# **ITS3 activities in Bari**

## **BBM6**

# BBM6\_ThermalTestAssembly\_03-04-2024.stp

## 5) SUPPORT STRUCTURE

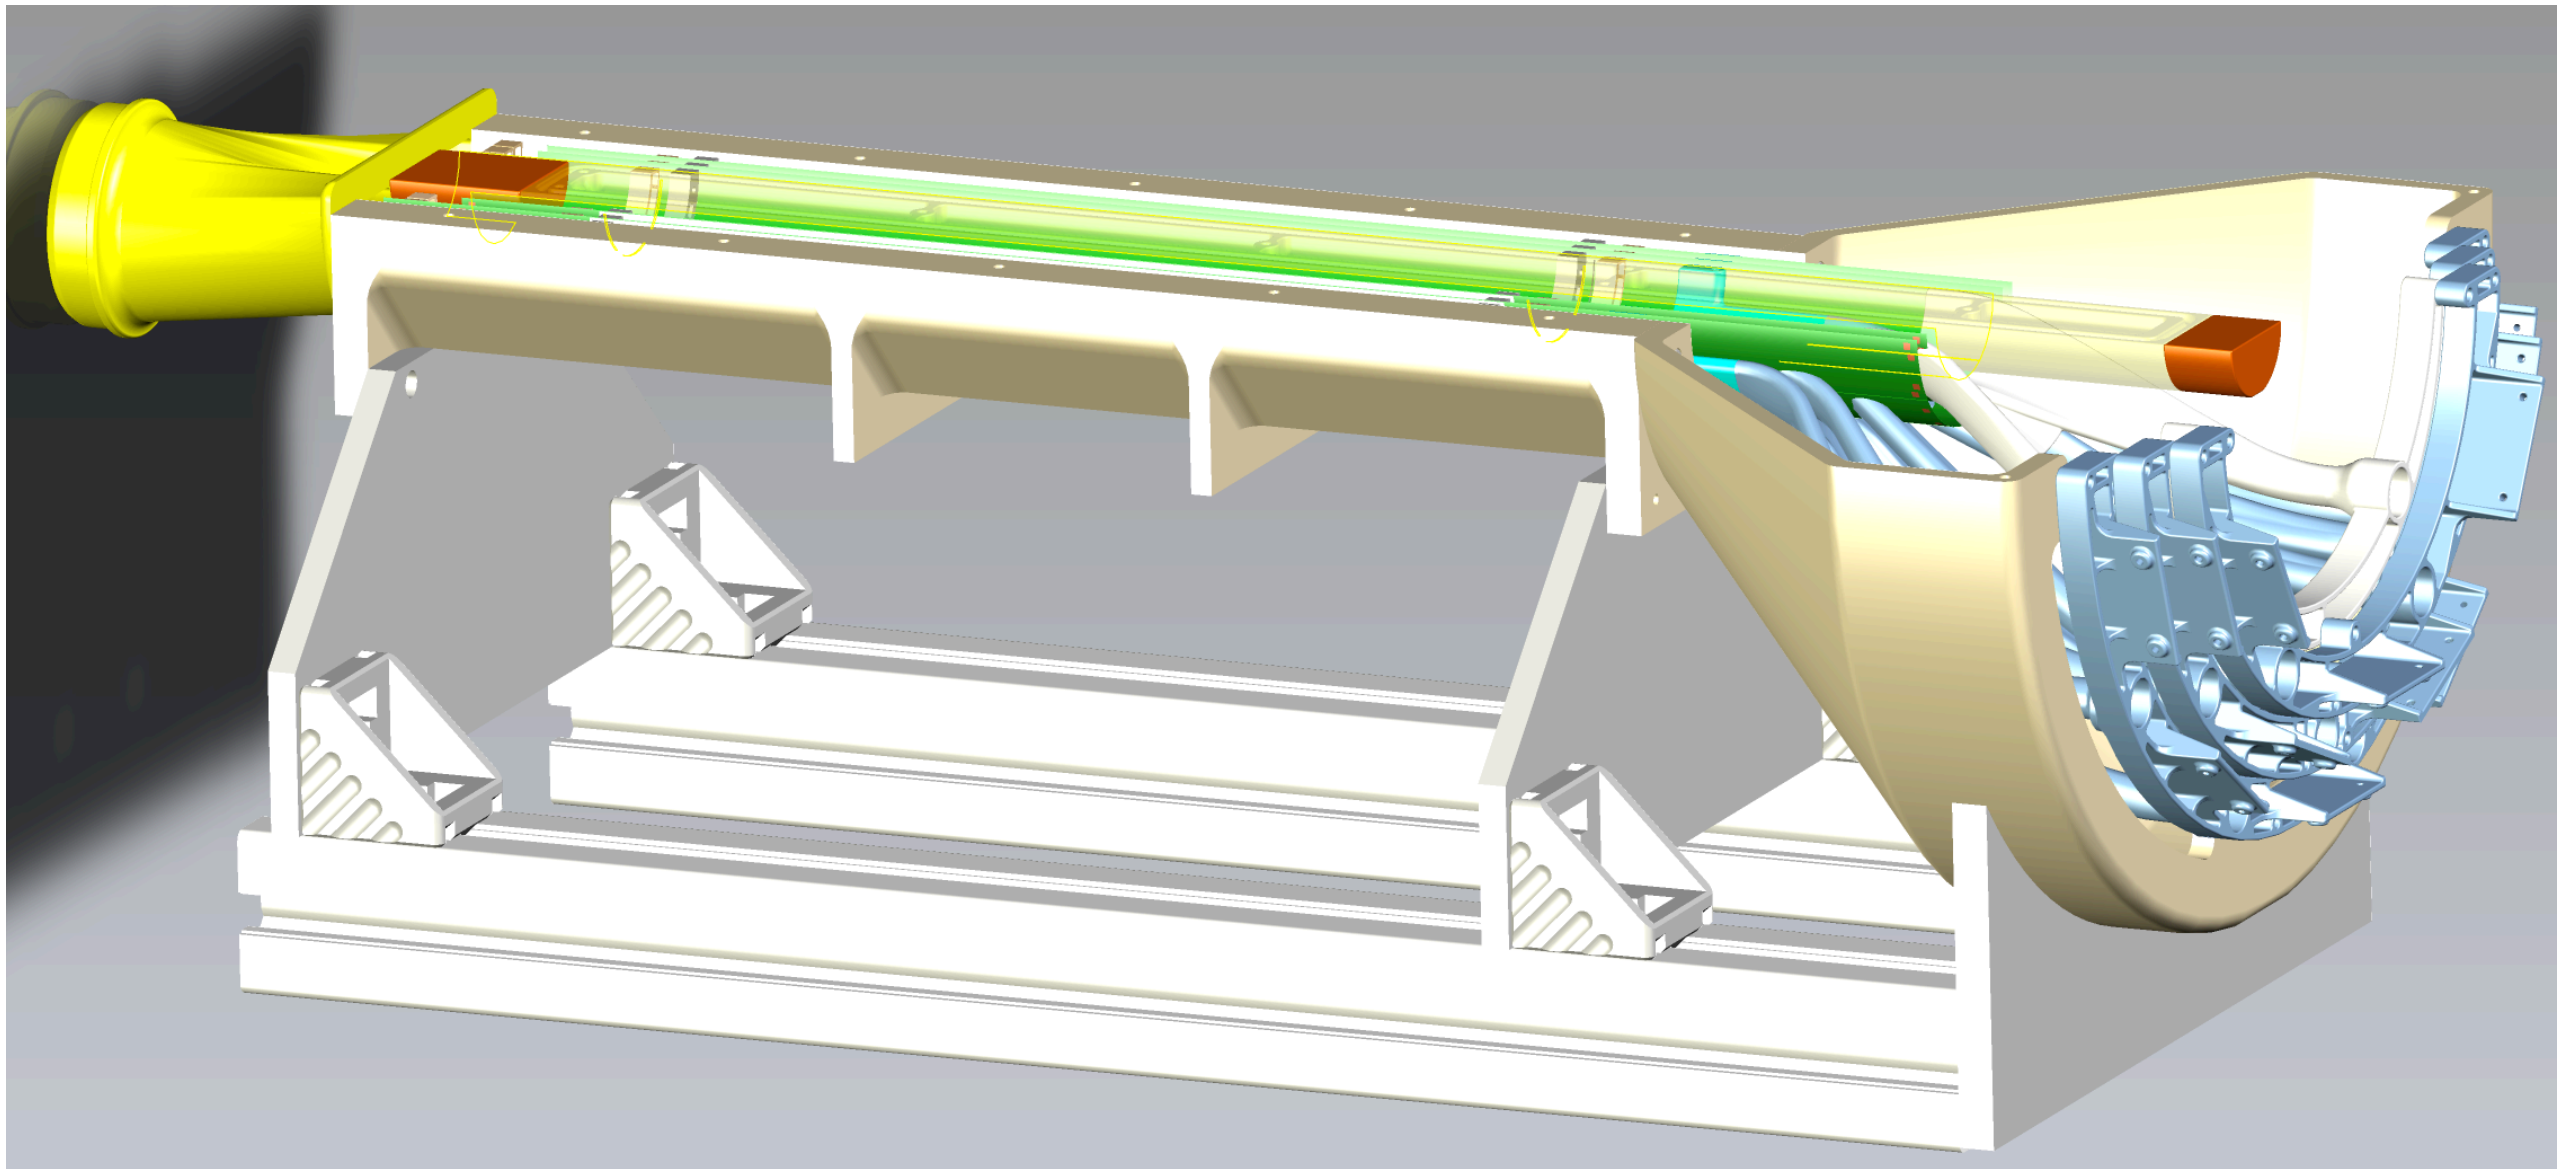
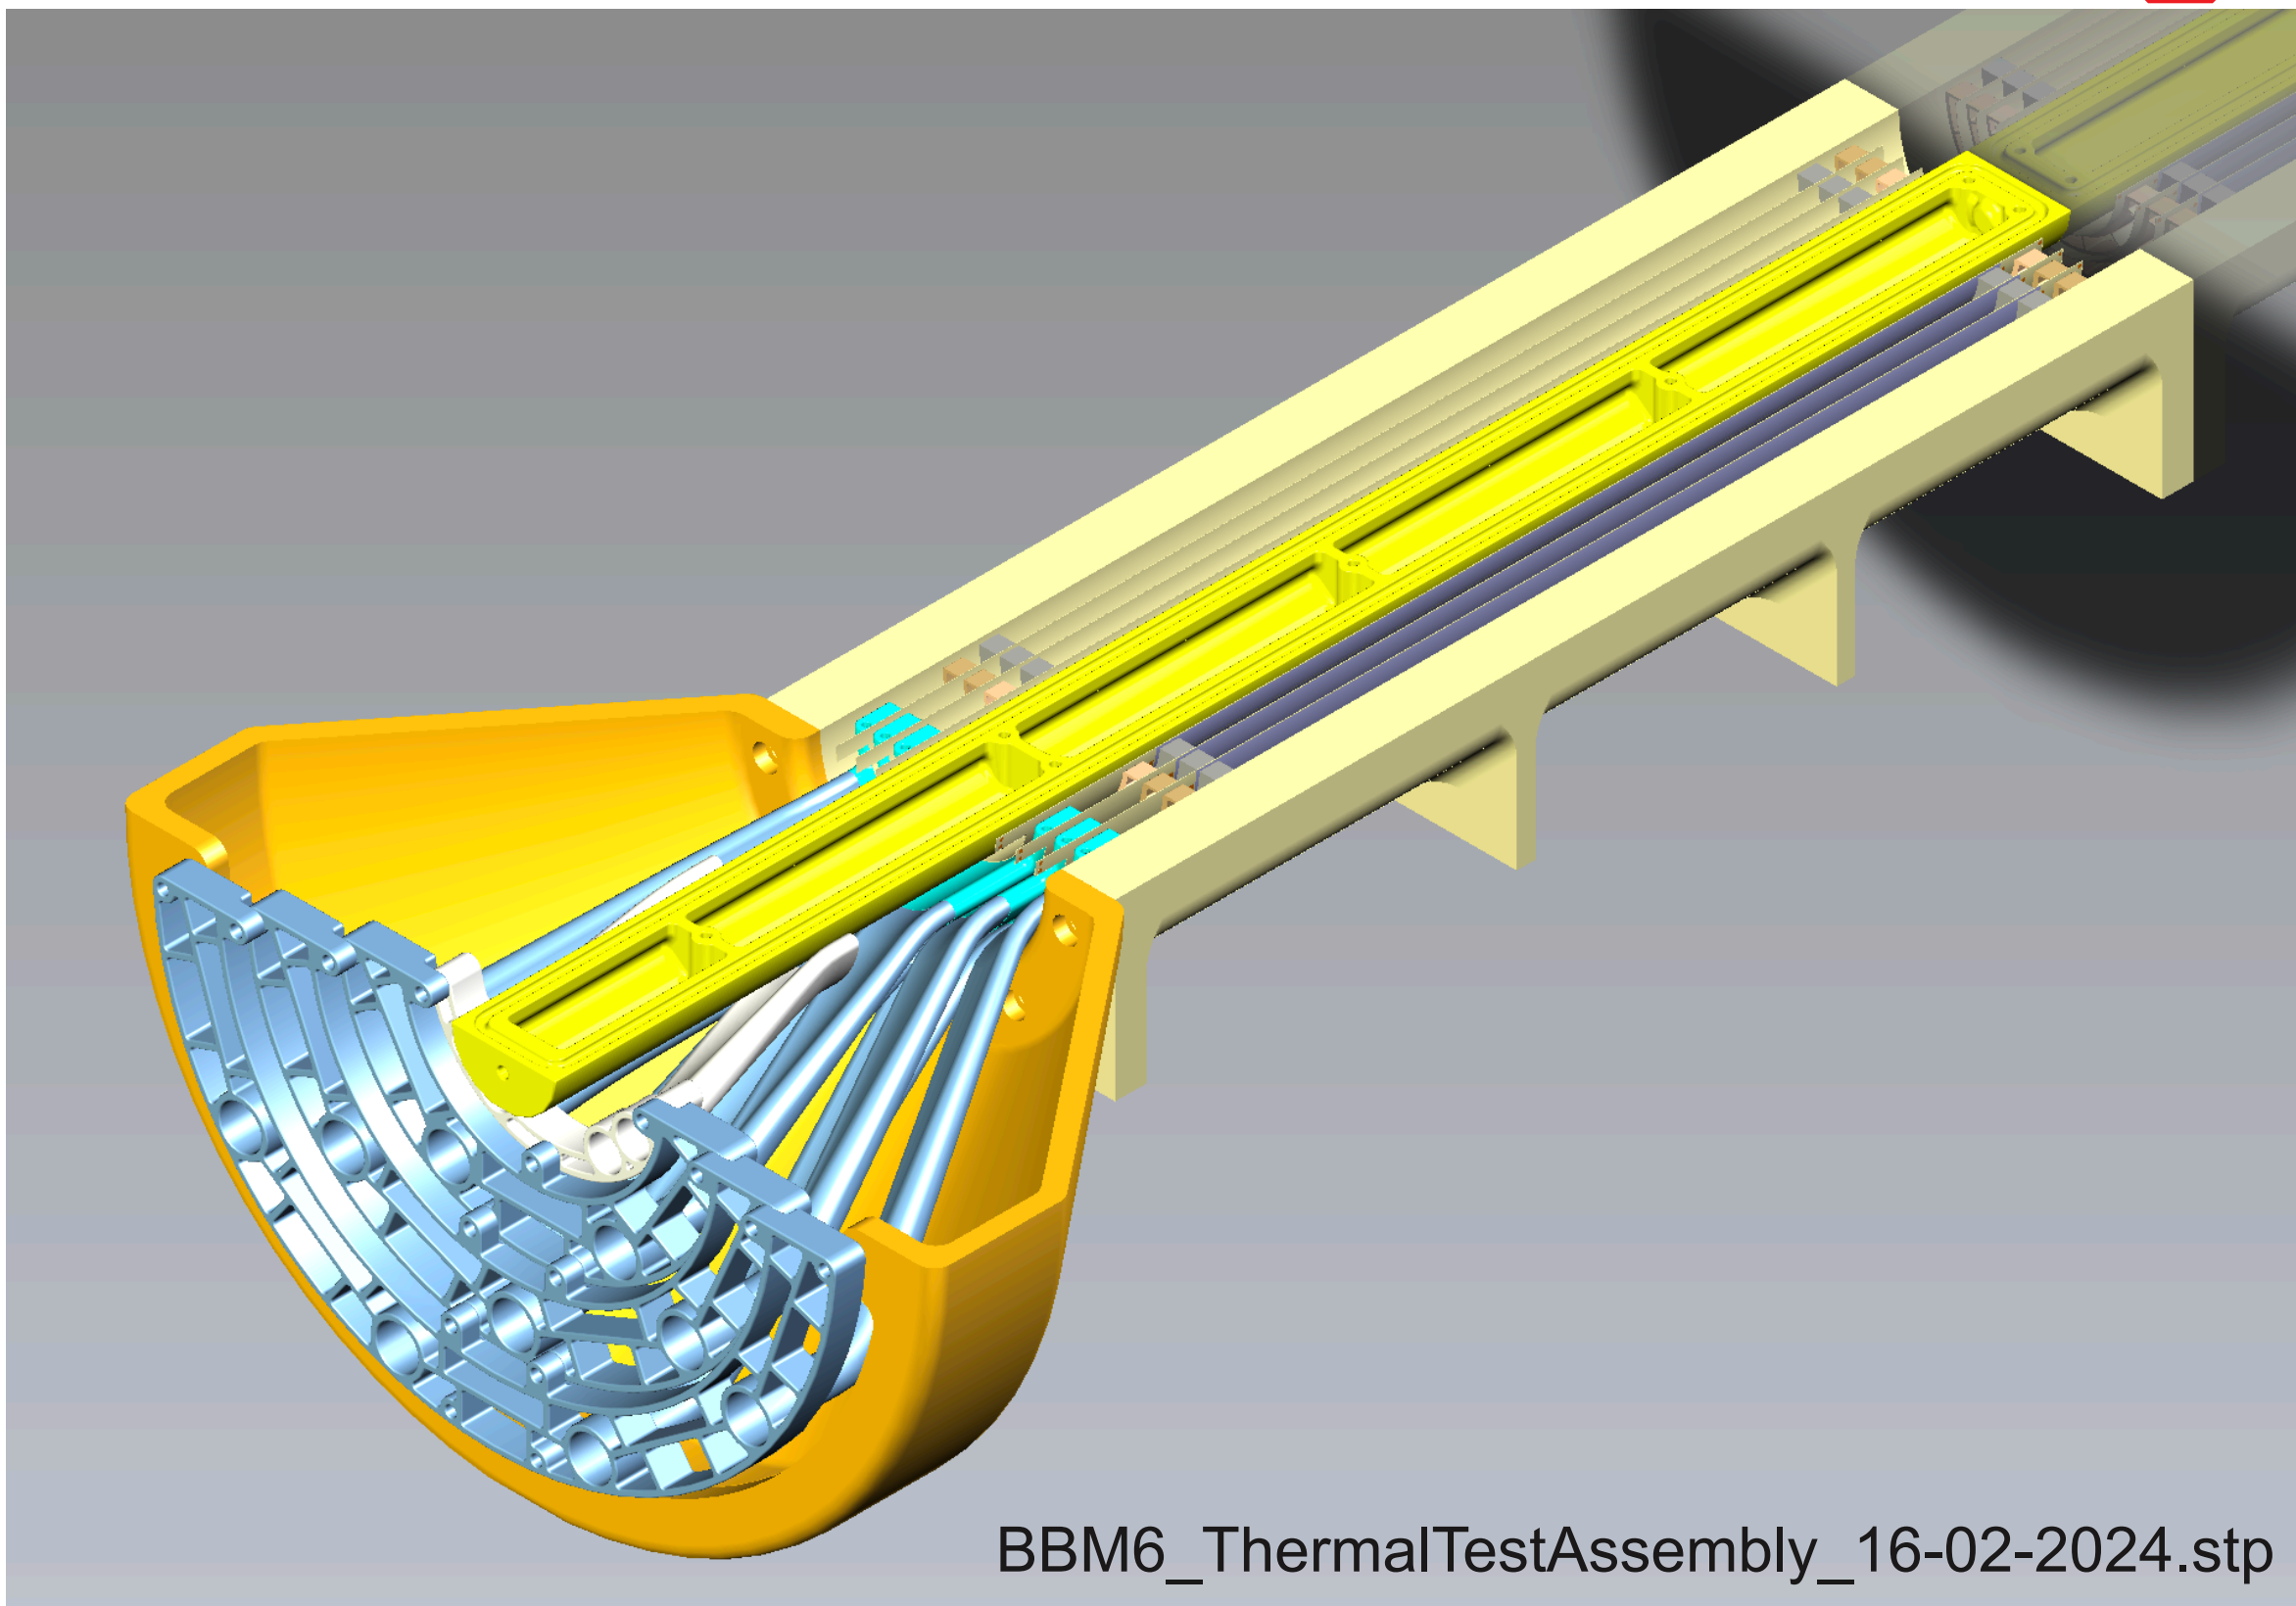
Is this solution compatible with wind tunnel?
